18/13 White/Turner Farm  
18/13-90A

RE: 19701 Bucklodge Road (HPC Case No. 18/13 - 90A)

SUBJECT: Ex Parte Communication: Manoocher Parvizian/Amin Fotowat  
Re: HPC Case No. 18/13 - 90A (19701 Bucklodge Road, Barnesville, Maryland)

CASE NUMBER: 18/13-90A

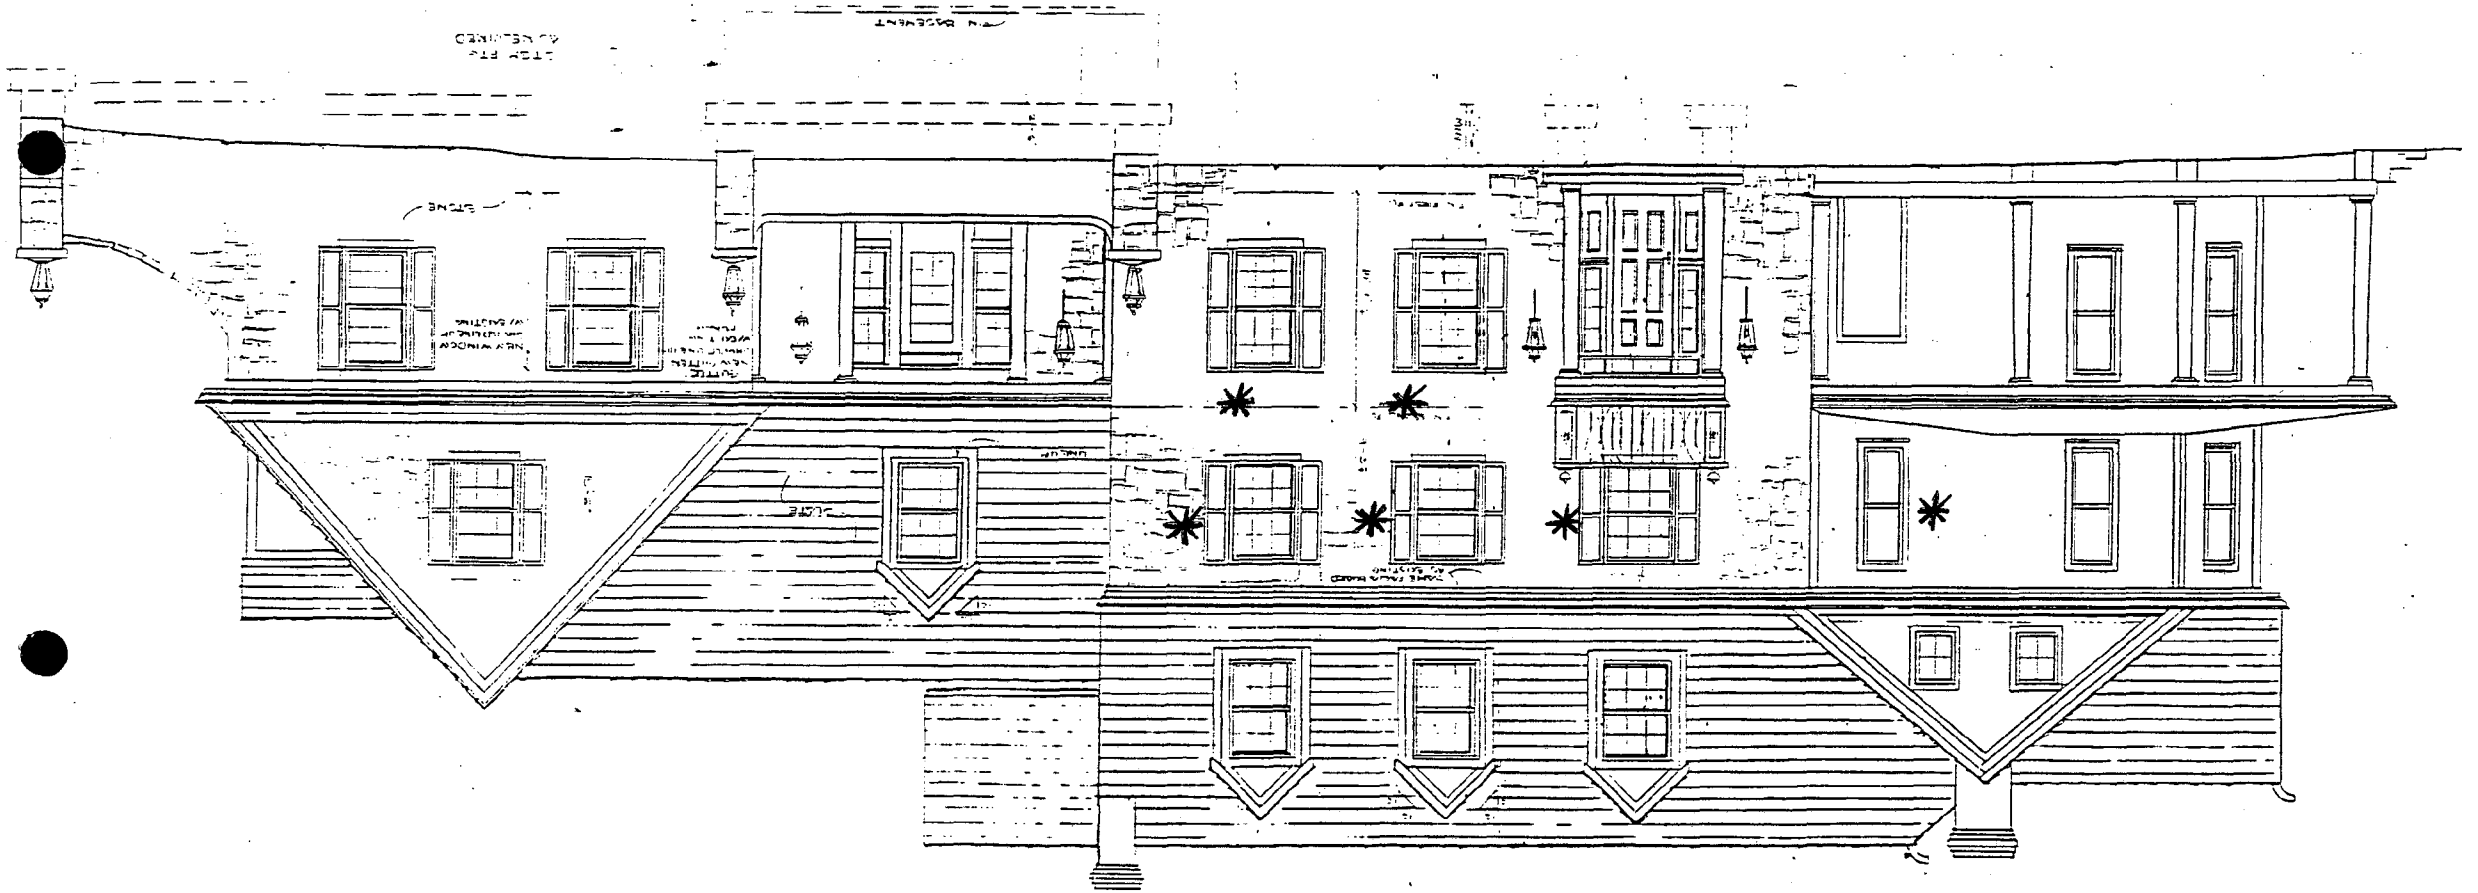
We proceeded to review the proposed design in light of these concerns. In the course of the discussion that followed, it was suggested that the two story entrance porch be changed to a more refined, smaller scale entrance feature, preferably one story high. We also discussed the new dormers on the front elevation; although not original, they are not uncommon on houses of this type. I suggested that a third dormer over the entrance bay would, in context, be appropriate.

The second area we discussed in detail was the garage wing. I recommended that the overall appearance of this wing be simplified and that the cupola be eliminated.

The last portion of the design we reviewed was the rear elevation and tower. The applicant was very reluctant to eliminate the tower, as he felt that it was a very distinctive feature both inside and out. I argued that the interior spatial qualities of the attic rooms could be created with a different roof line. I urged the applicant to explore alternative solutions that were more in keeping with the reserved Queen Anne style of the Victorian addition, as well as below the existing ridge line to the main block of the house.

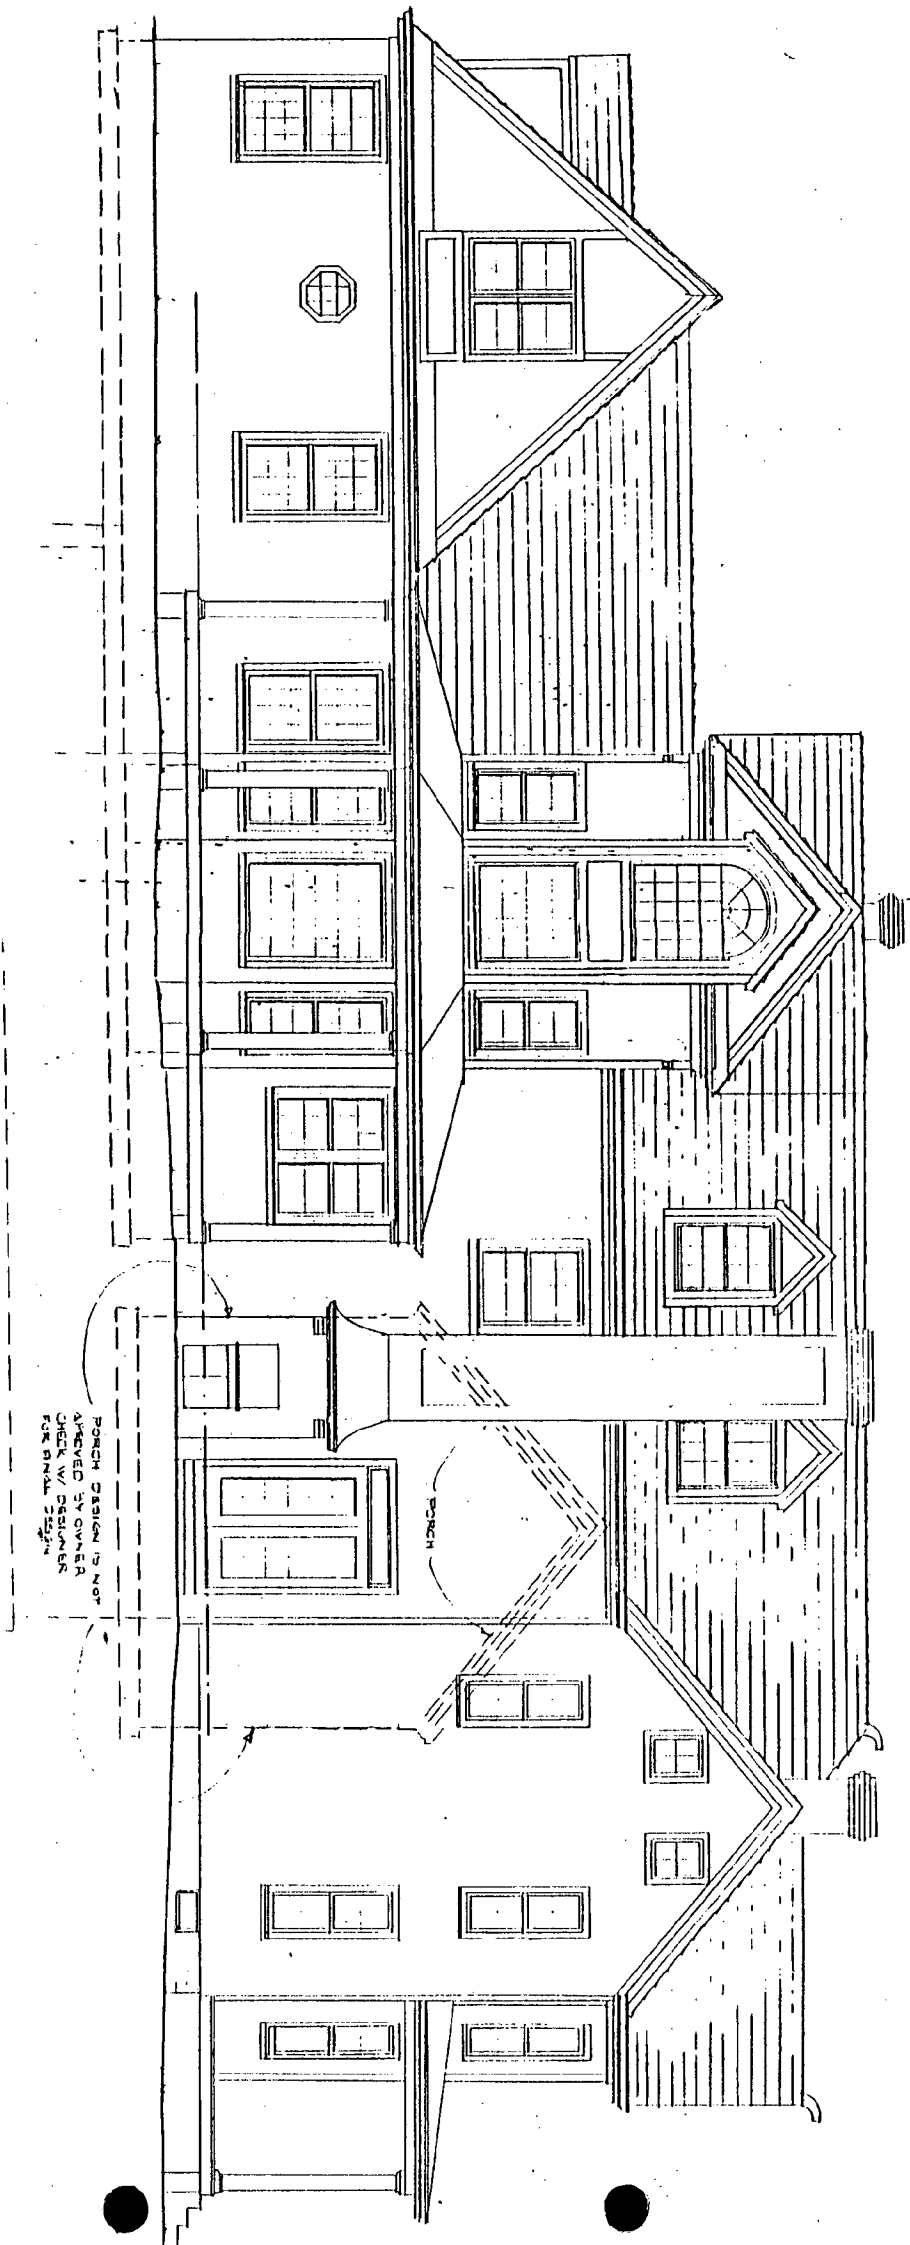
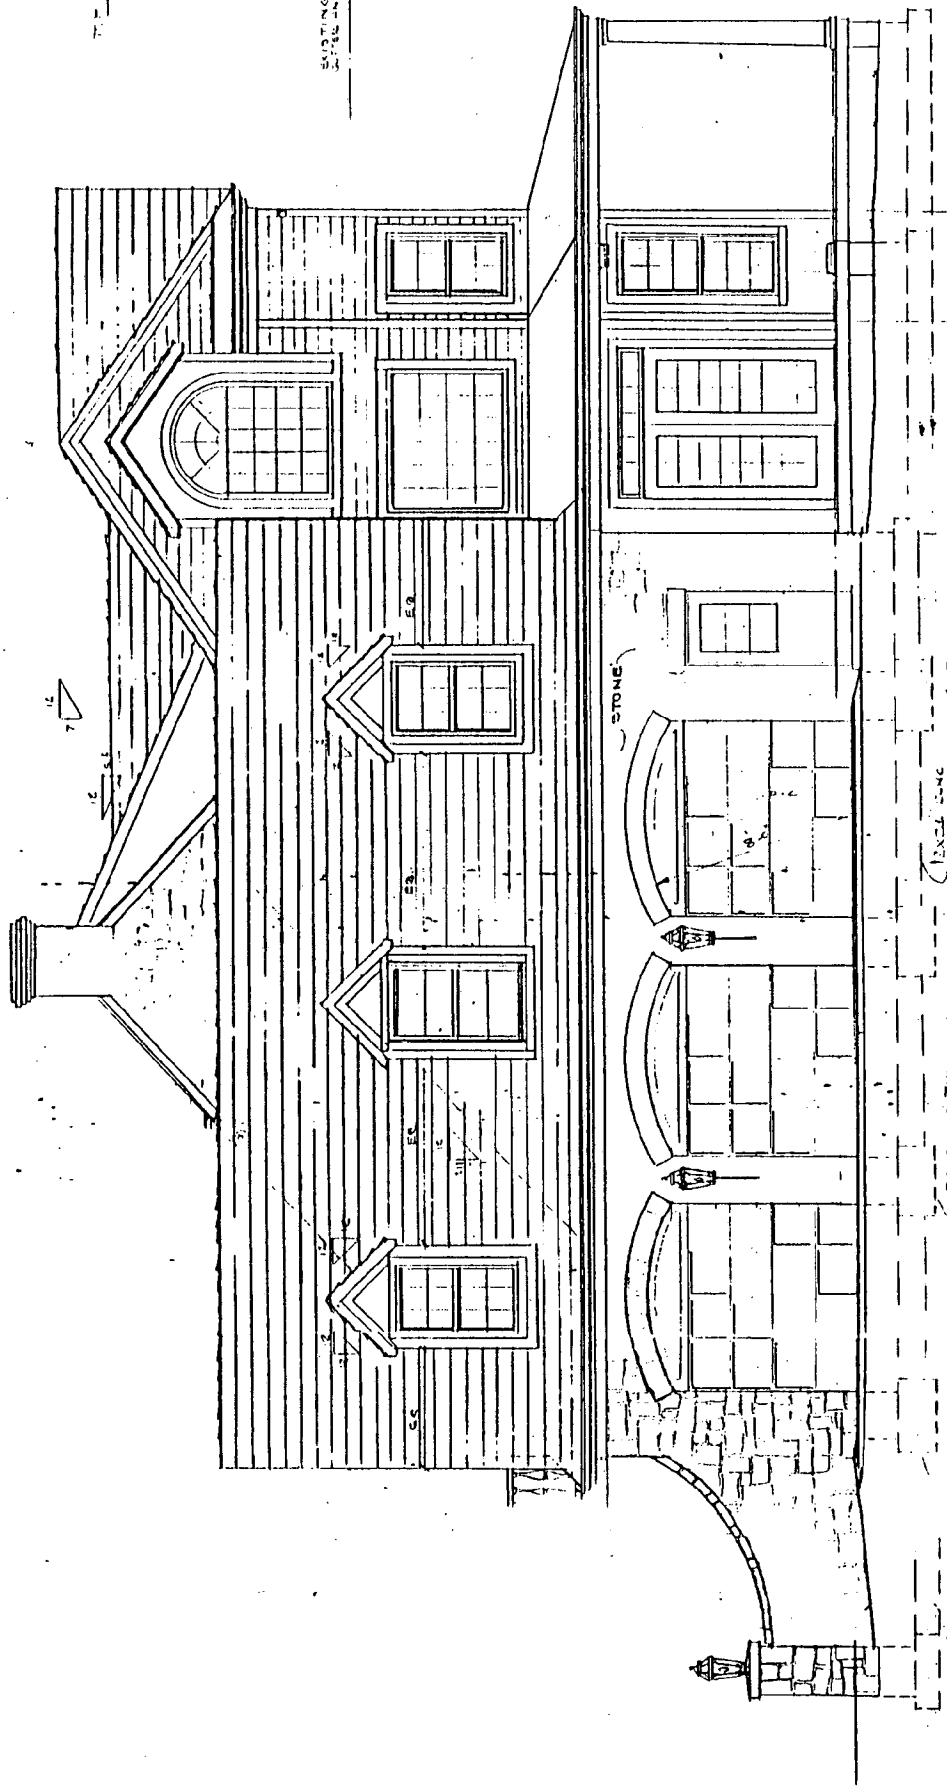
\* Windows to be replaced

PORCH DESIGN IS NOT  
APPROVED BY OWNER  
CHECK W/ DESIGNER  
FOR FINAL DESIGN

REAR ELEVATION

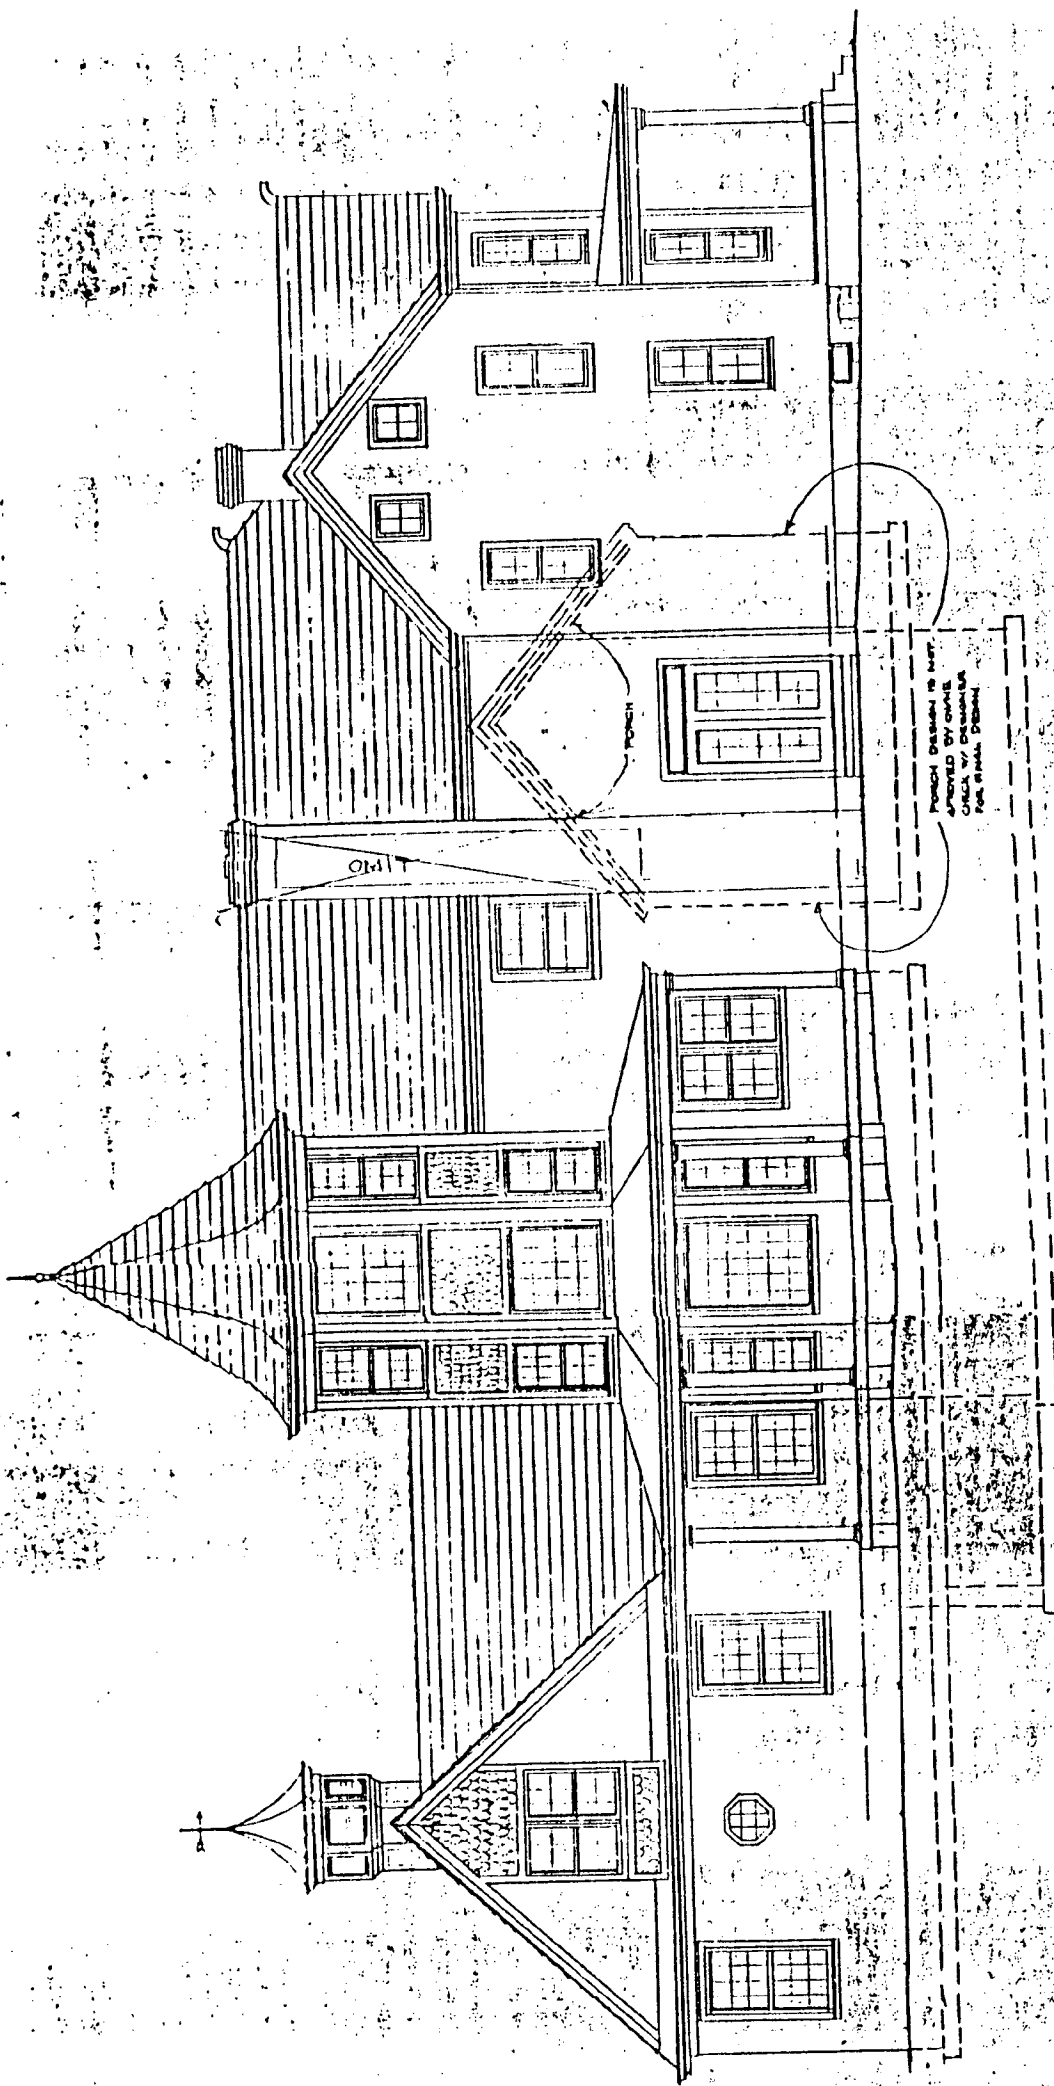
POUCH DESIGN IS NOT  
APPROVED BY OWNER  
CHECK W/ DRAWINGS  
FOR OTHER DETAILS

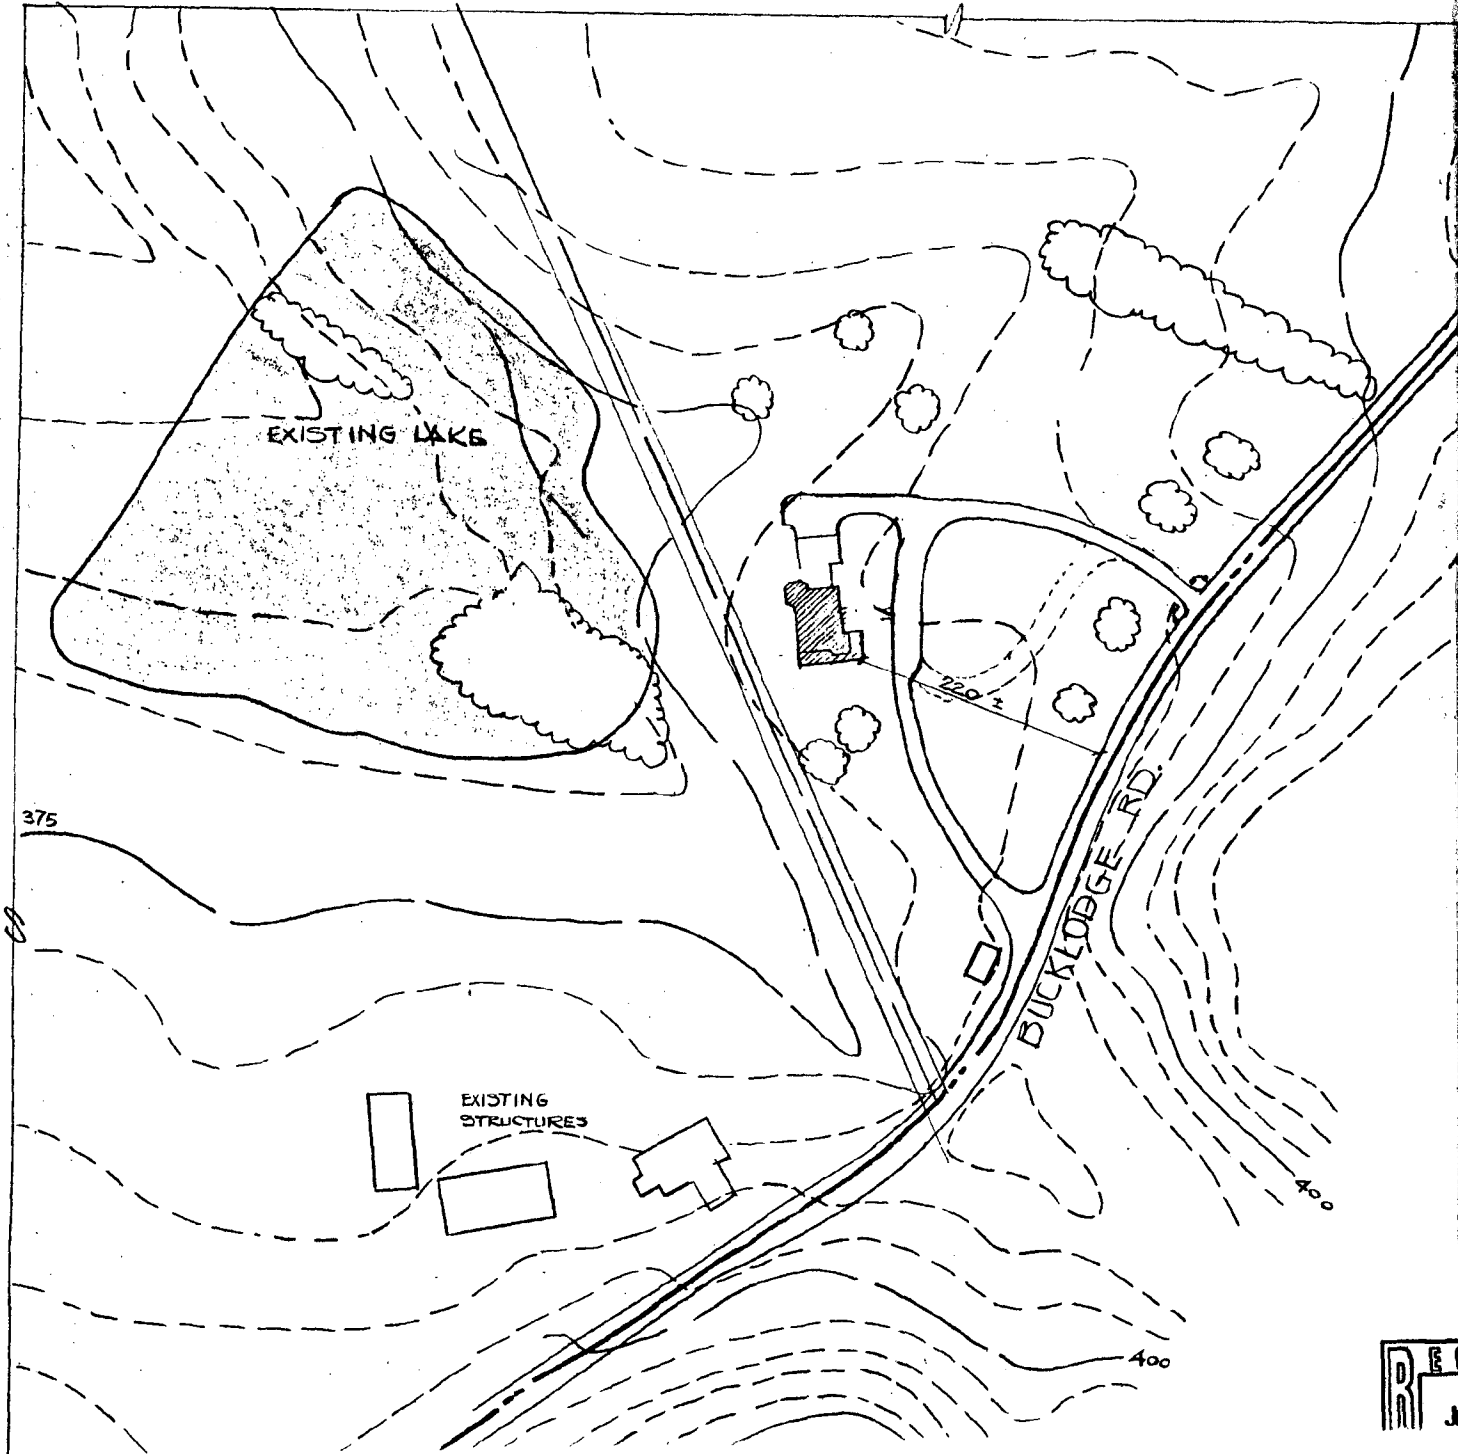
*Not approved by the Hist. Pres. Commission.*
